UNIT MIX

TOWNHOMES: 60 units
TWINS: 22 Units
SF COTTAGE: 30 Units
SF 50' PRODUCT: 44 Units
TOTAL: 156 UNITS

156 UNITS / 24.6 ACRES = 6.34 DU/ACRE

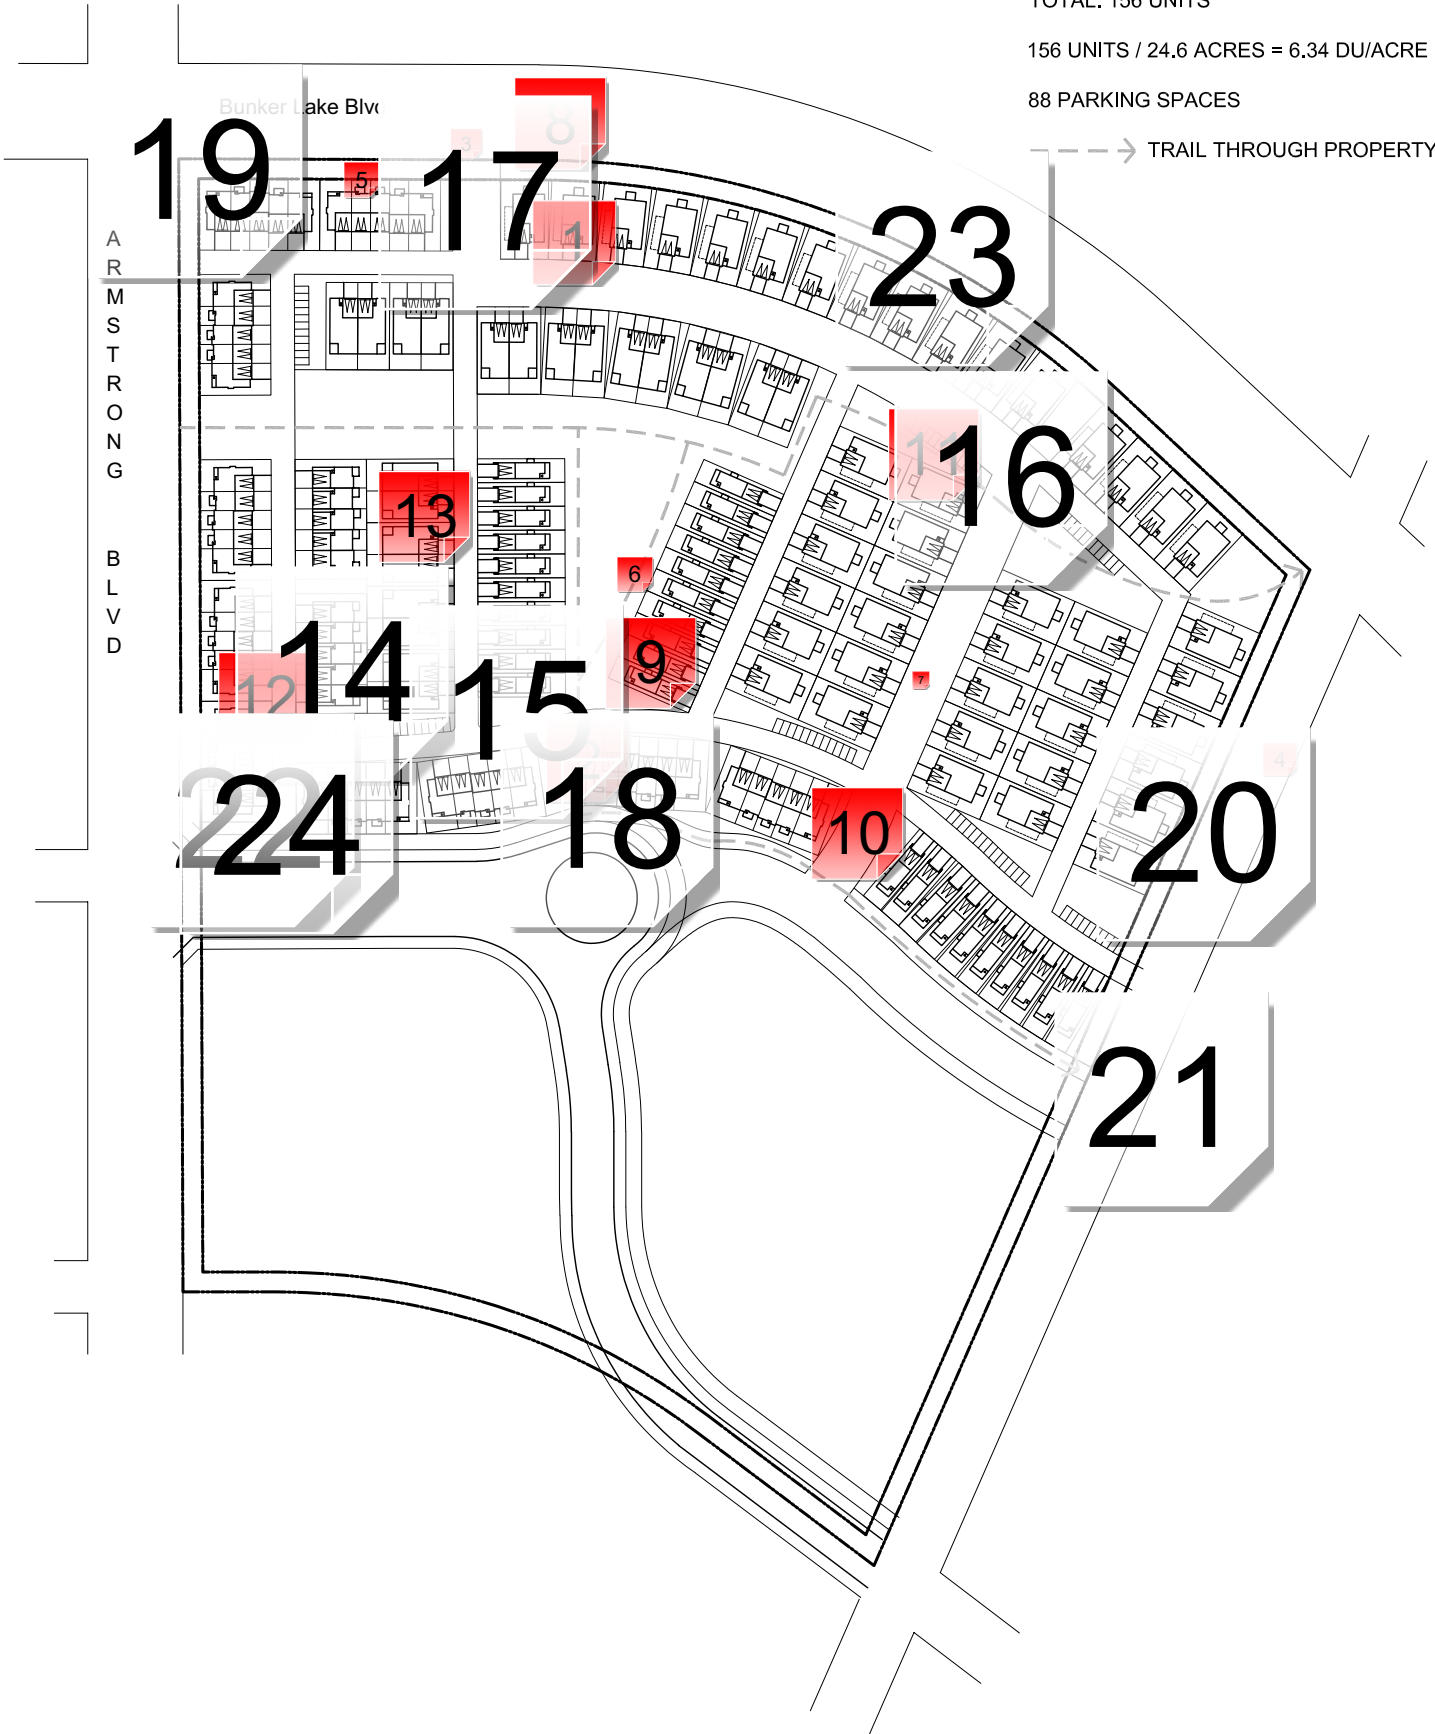
This access would be right in/out only due to median and would need to be approved with county.

Consider running roundabout connection to the north to make route through development more direct, improve traffic flow

My understanding is Anoka County will not allow additional access along Bunker, this would need their approval.

Zeolite Street is not a final street design at this point. There would likely be some kind of cost-share required for the street improvements. Something to be aware of.

Other Developments along Bunker have needed to extend the Trail/wide sidewalk, assumption is this will be required here as well.

Please keep in mind that the existing site is low and will require fill. Wetlands exist on-site as well.

Assuming the wider areas are City Right-of-Way, should be labeled for clarification if there is a mix. Would prefer the city streets loop to other City Streets with better flow. Are the trails to be maintained by the city, or a combination?

Right of access to Bunker Lake Blvd was dedicated to Anoka County with the current plat. Creating an access in this location will require approval from Anoka County.

The accesses to this project must be on Zeolite Street and at the round about as noted in another comment.

The existing wetland was created as a mitigation area for construction of Bunker Lake Blvd. Filling a mitigated wetland will require additional review and construction of a new mitigation area. This must be factored in the proposed schedule for this project.

The southern access must be placed to connect to the roundabout. If this access is placed in this location it should be right in - right out. Vehicles trying to make a left turn out of the development do not have clear sight lines for deciding when it is clear to turn.

Permanent Screening must be provided between this parking areas that face the sides of buildings so that headlight glare is not visible in the buildings. The screening should be a berm with dense vegetation on top.

This pond provides drainage for Armstrong Blvd. The storage must be accounted for in the design.

The development must pay into the City infiltration mitigation fund.

Sidewalk Required on one side of all public streets

Reserve area for commercial here

Trail corridor needs to go from NW corner to middle section of east property line, recommend using this as a natural feature as trail corridor is greenway. City will take ownership of corridor.

This needs review from Anoka County but could likely only be RIRO. Make clear how intersections between public and private roads work. How wide are roads?

Recommend main street coming off roundabout north

Greenway will be 10 foot trail

Fronts of homes will need to face roads, stone and porch on each home or high quality architecture. 4 x 6 porch at a minimum.

Road needs improvements, will need to be partially funded by developer (minimum)

These are mitigated wetlands that will need to be relocated. FYI site is in COR infiltration area so no infiltration allowed onsite. Pay fee instead.

Bunker Lake Blvd is being improved, Staff will find plans to share.

Reserve for commercial
